Planning and Zoning Commission - Special Meeting AGENDA

**STAFF REPORT
KETCHUM PLANNING AND ZONING COMMISSION
MEETING OF JULY 27, 2021**

PROJECT: Crossbuck West Townhomes

APPLICATION: Design Review and Townhouse Subdivision Preliminary Plat

C2

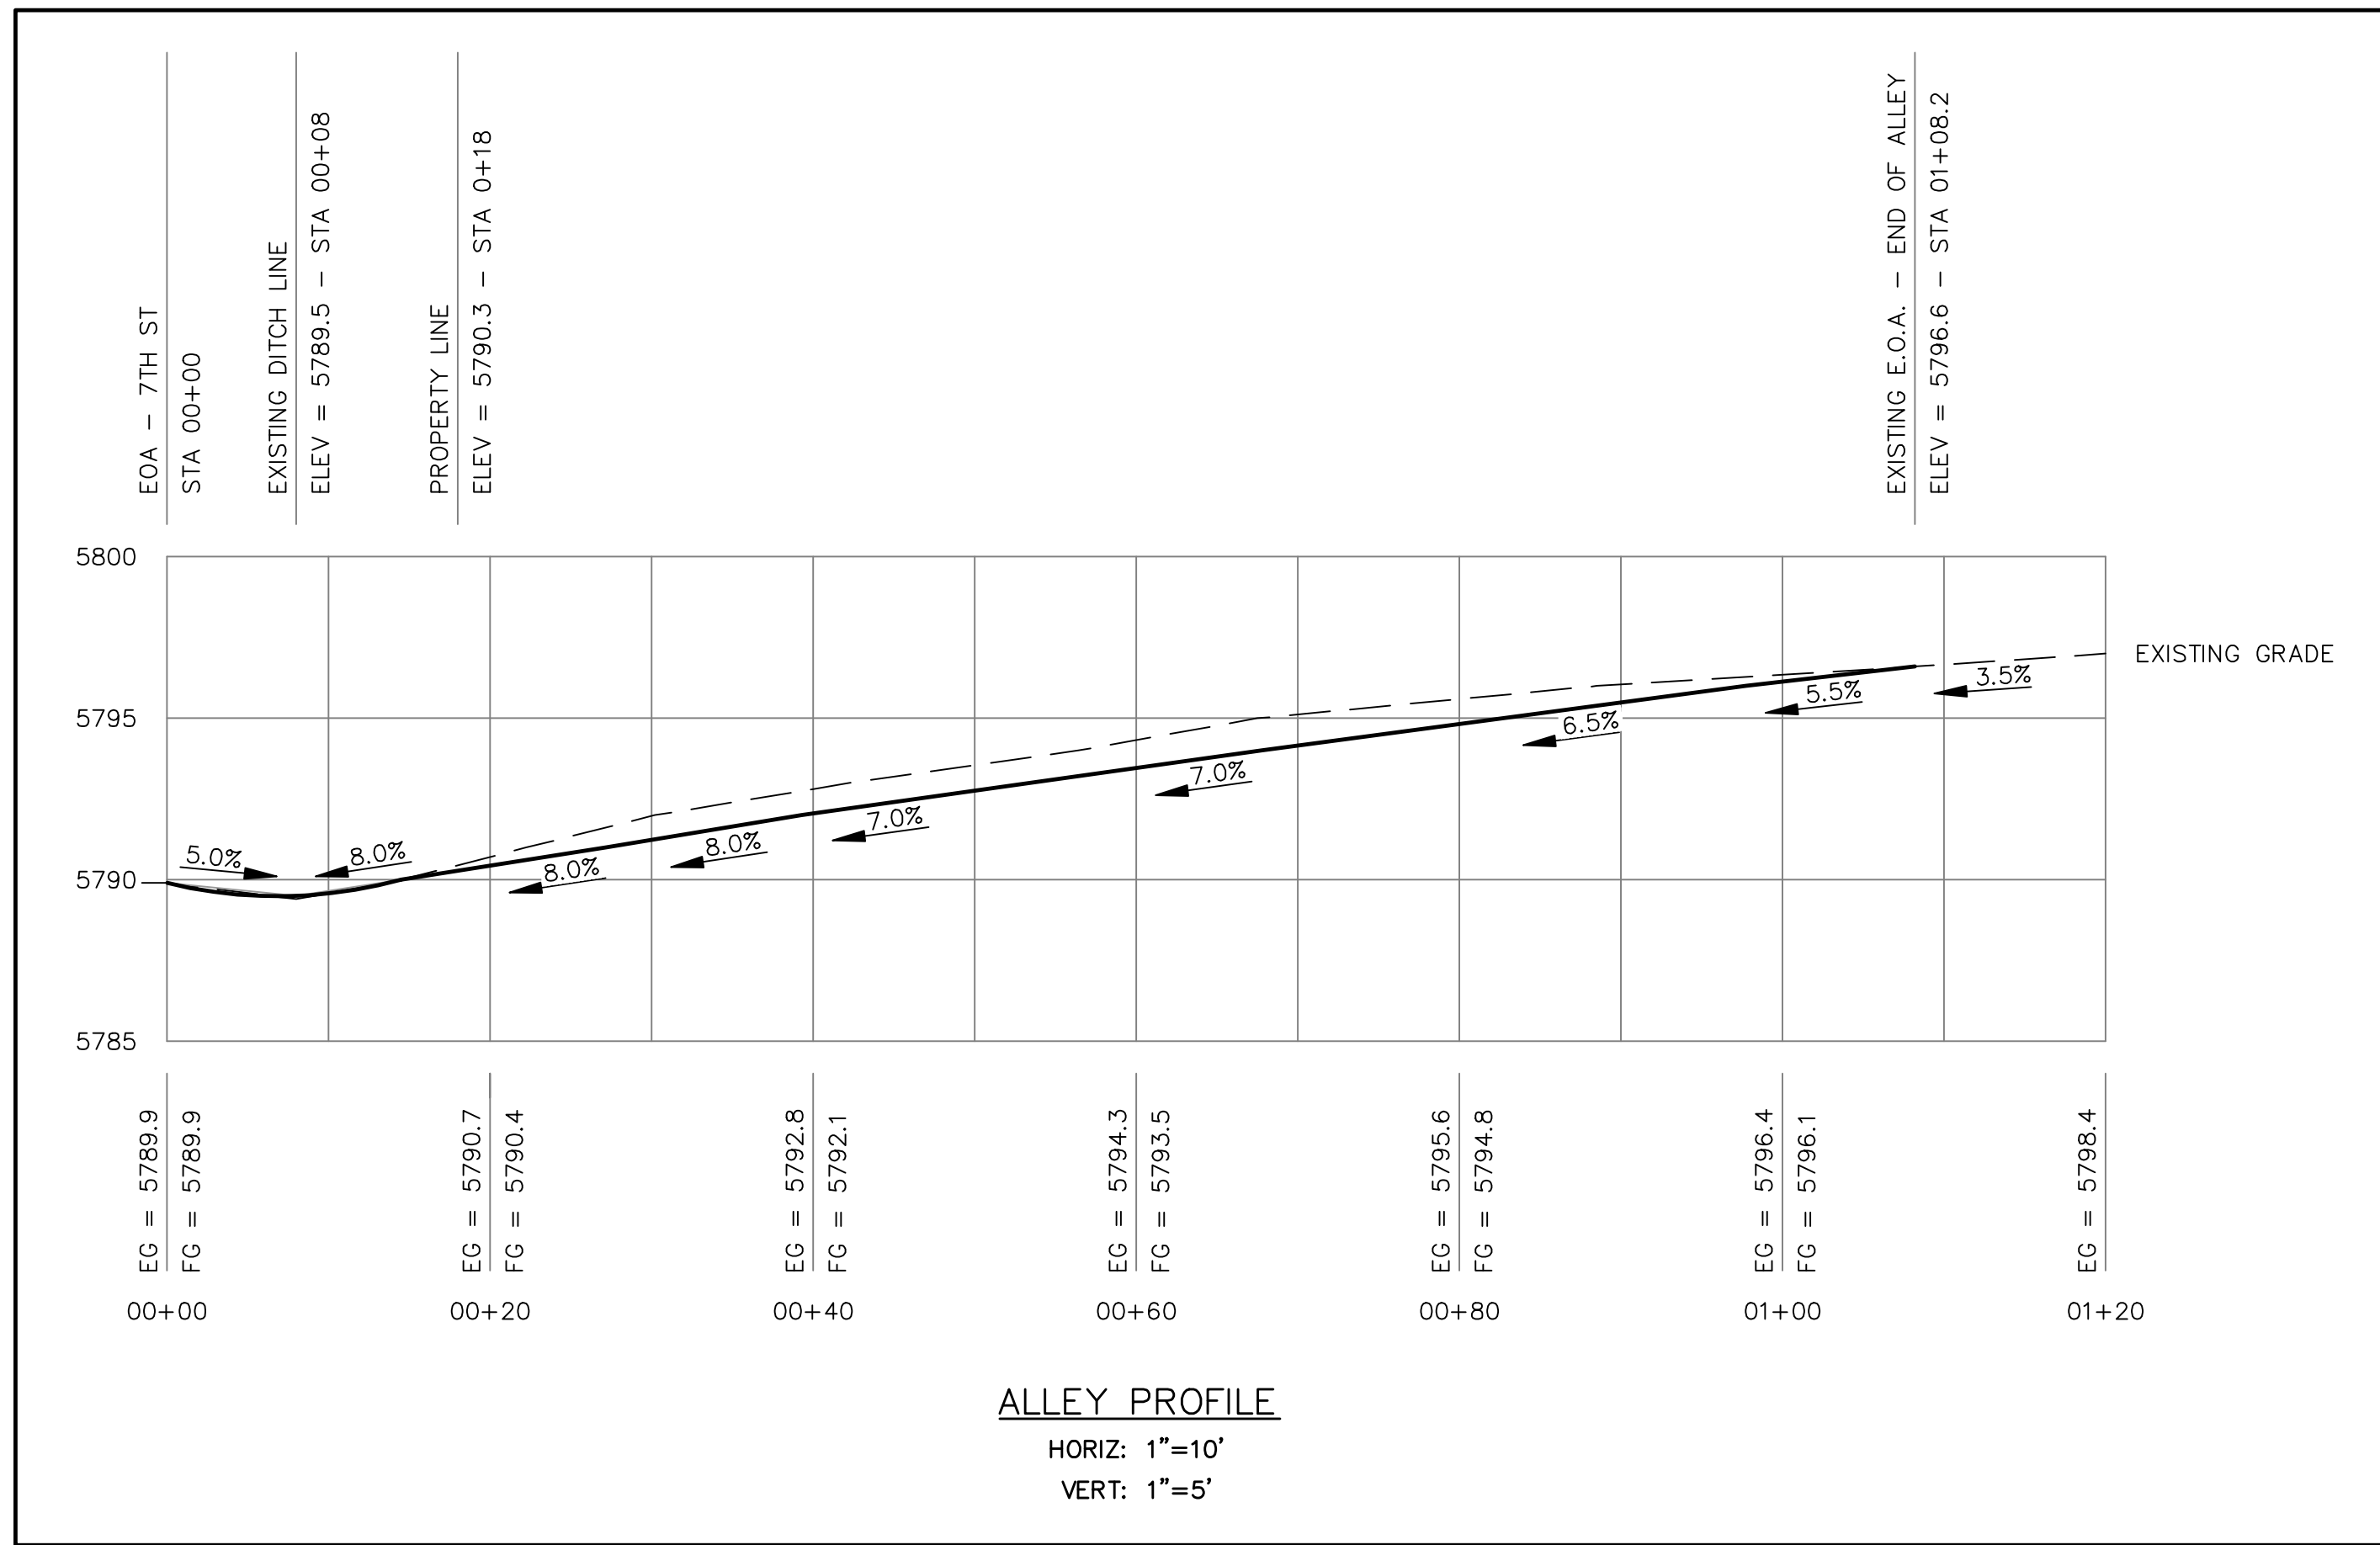
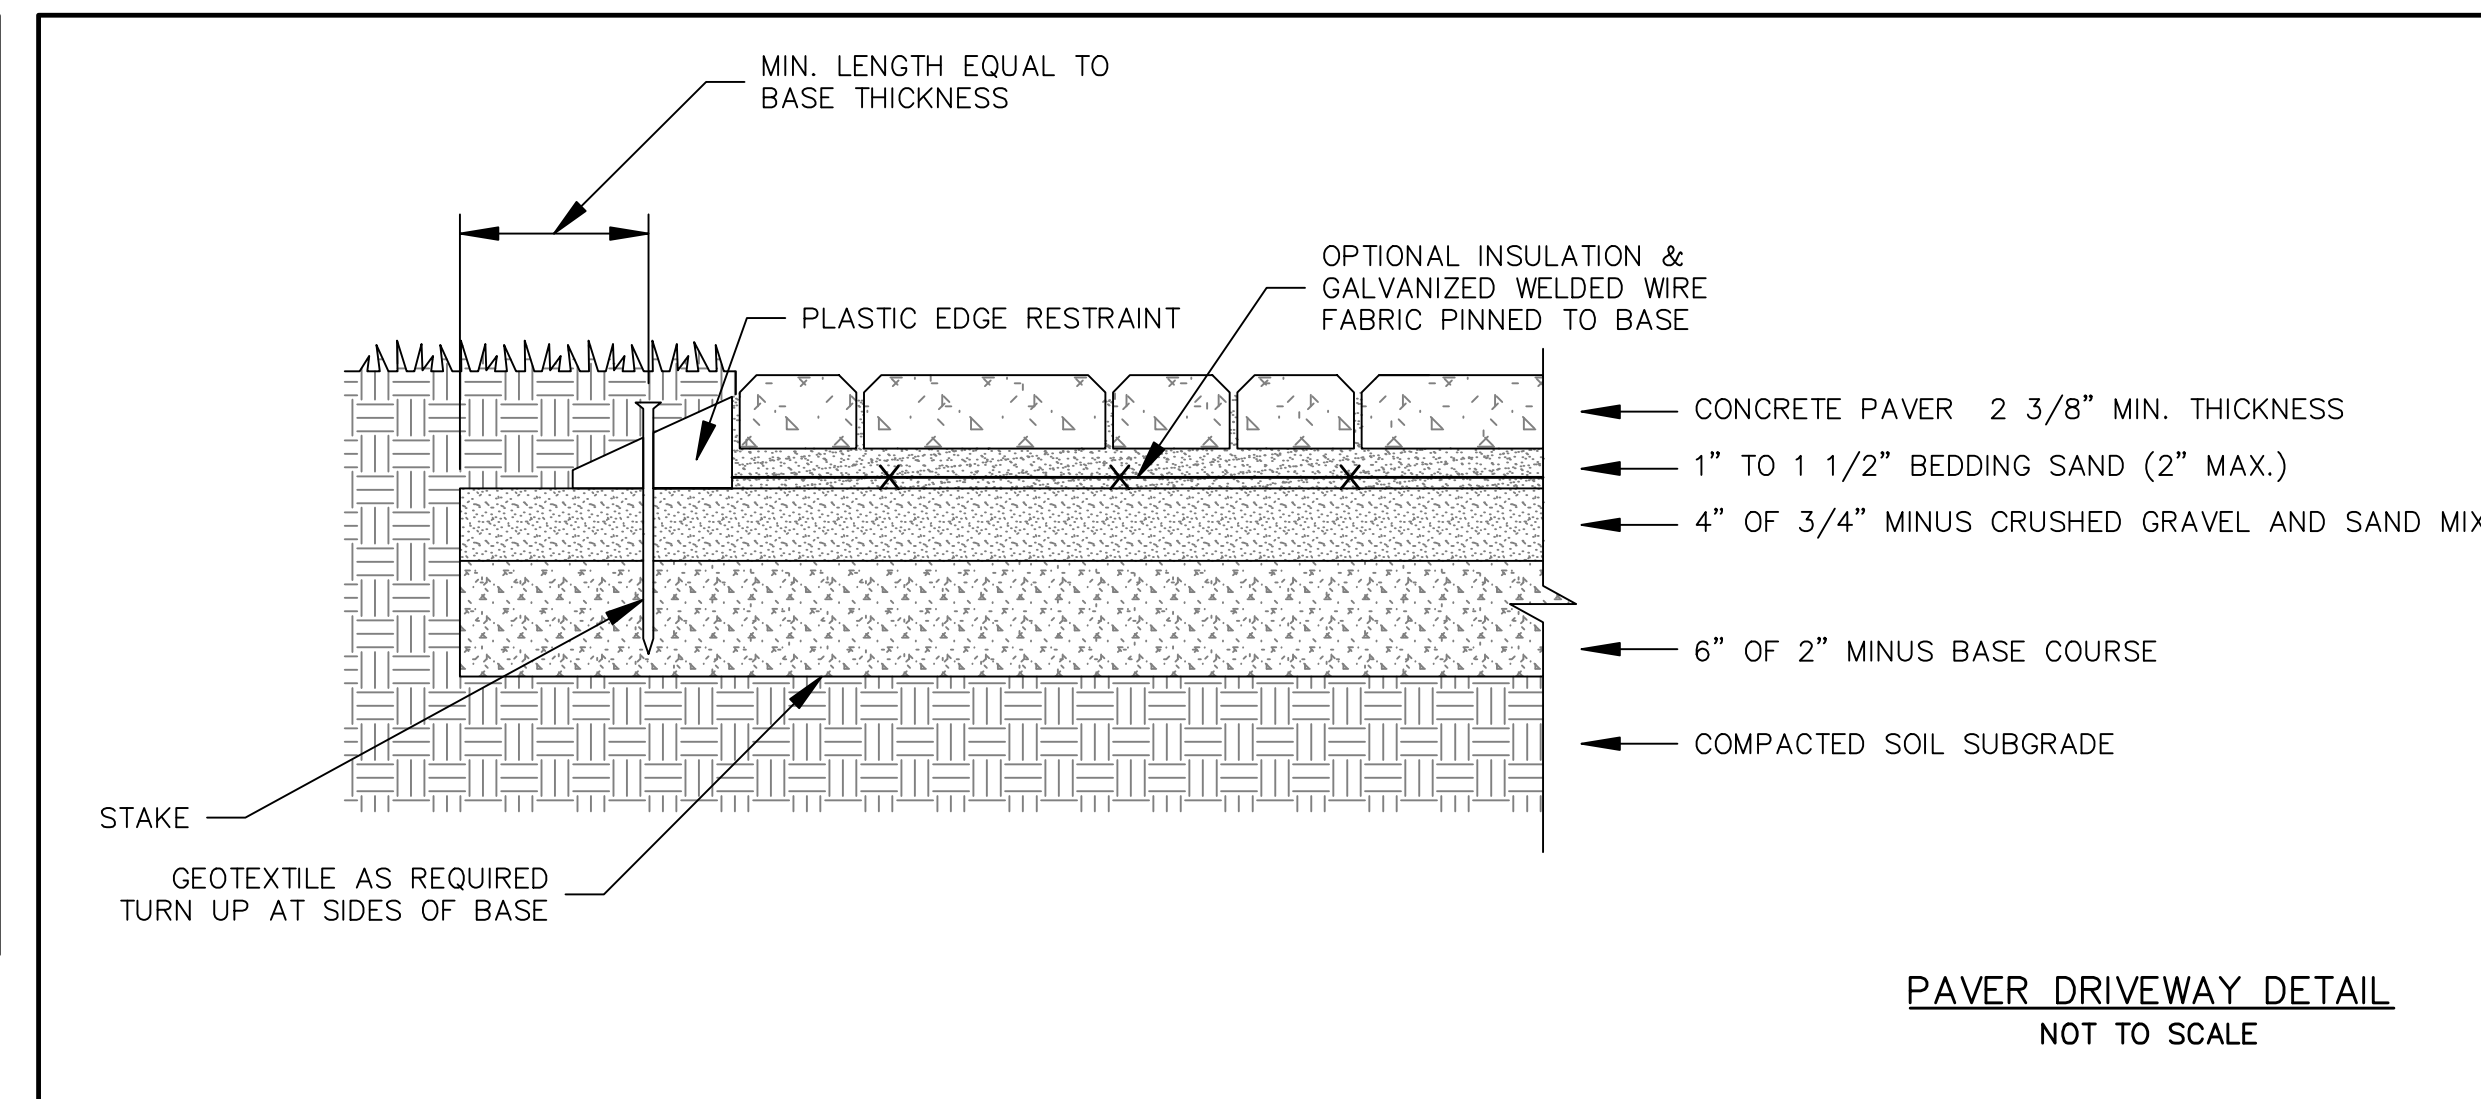
<p>The applicant shall improve the right-of-way (ROW) adjacent to the front property line along 7th Street to City ROW standards for residential roadways. The required right-of-way improvements are indicated on Sheet C2 of the project plans. Material shall be pervious/permeable to allow drainage. Surface must allow for vehicle parking and be consistent along the entire property frontage. Material within the first eight (8) feet from edge of asphalt shall be distinct from driveway and rest of property in order to visually appear to be available for parking. Grading and drainage improvements must meet the following standards: minimum 5% slope, no obstructions, such as boulders or berms, no buried irrigation systems within the first eight (8) from the edge of asphalt, and no subsurface irrigation lines are permitted beyond the first eight (8) feet, however popup heads are not permitted anywhere in the ROW. No live plant material within the first eight (8) feet from edge of asphalt. Low ground cover plant material, such as turf grass, is permitted beyond the first eight (8) feet. Drought-tolerant species is preferred. The applicant shall improve the remainder of the Block 67 alleyway to City standards.</p> <p>Final civil drawings for all associated ROW improvements shall be submitted with the building permit application to be reviewed and approved by the City Engineer and Streets Department prior to issuance of a building permit for the project.</p> <p>See Table 1 for comments and conditions from the City Engineer & Streets Department.</p>

Sheet No:
L3.0

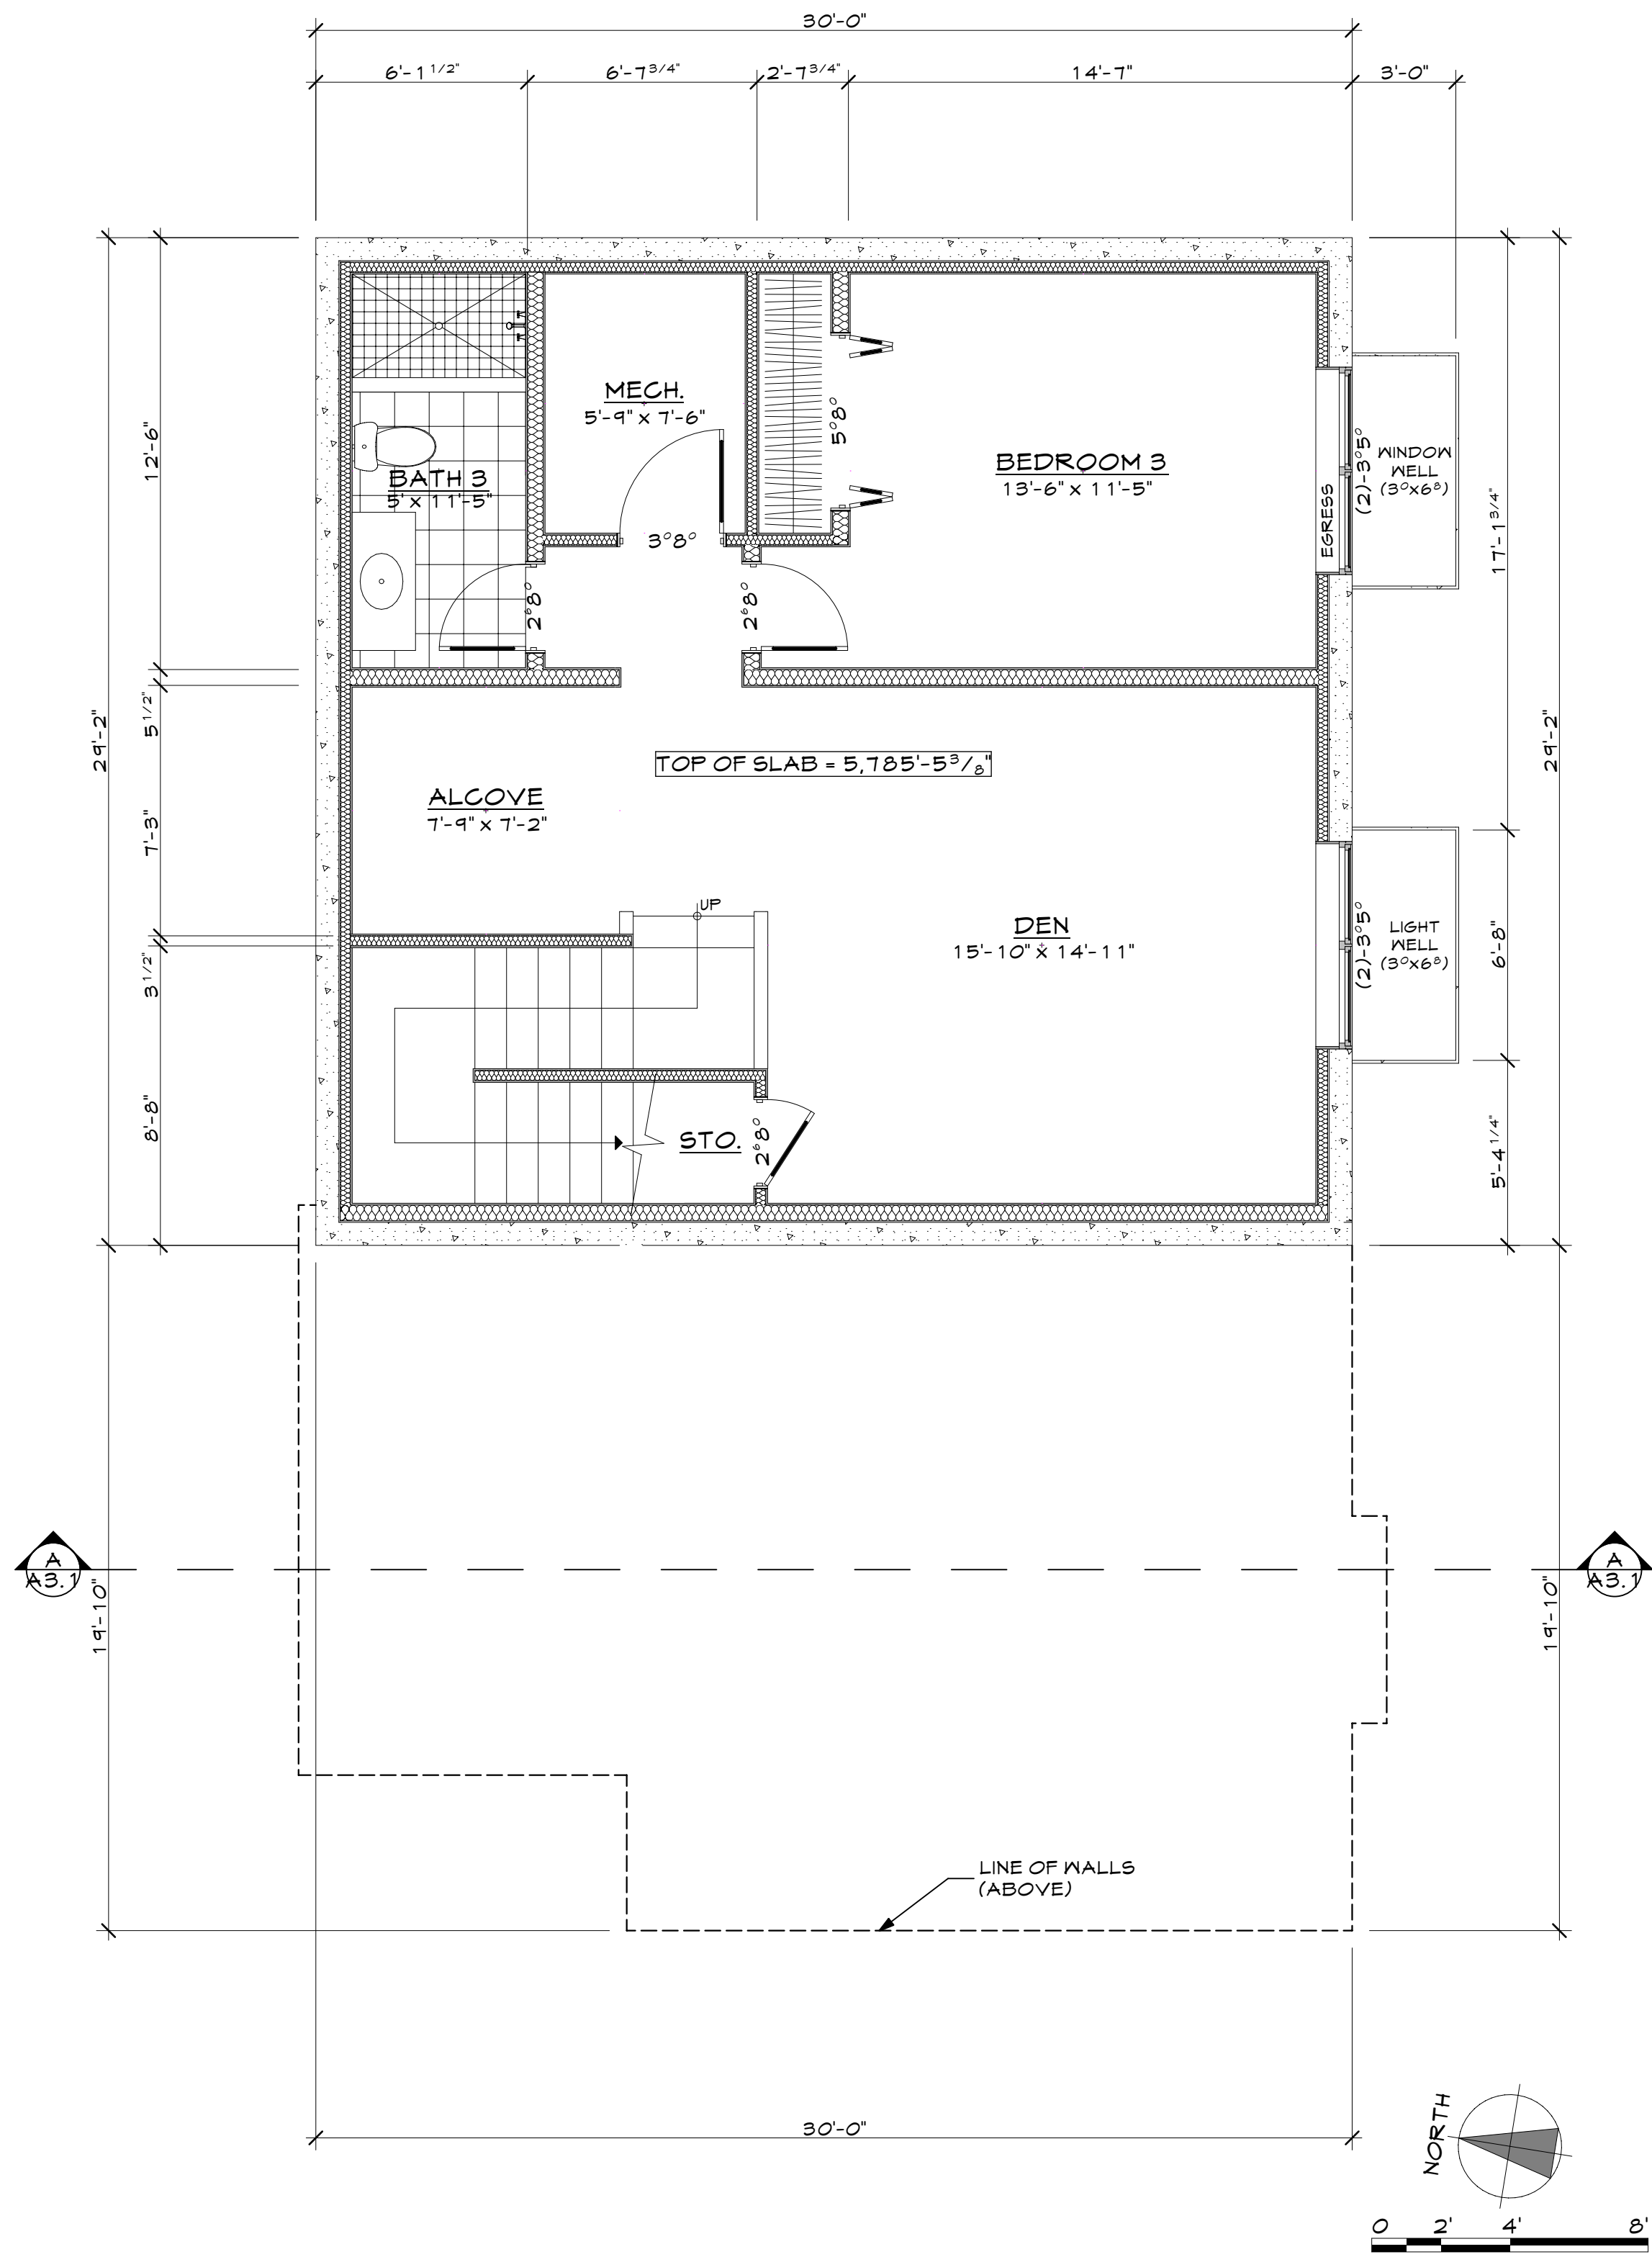
Staff Comments	The applicant will install new landscaping as indicated on Sheet L-3.0 of the project plans.
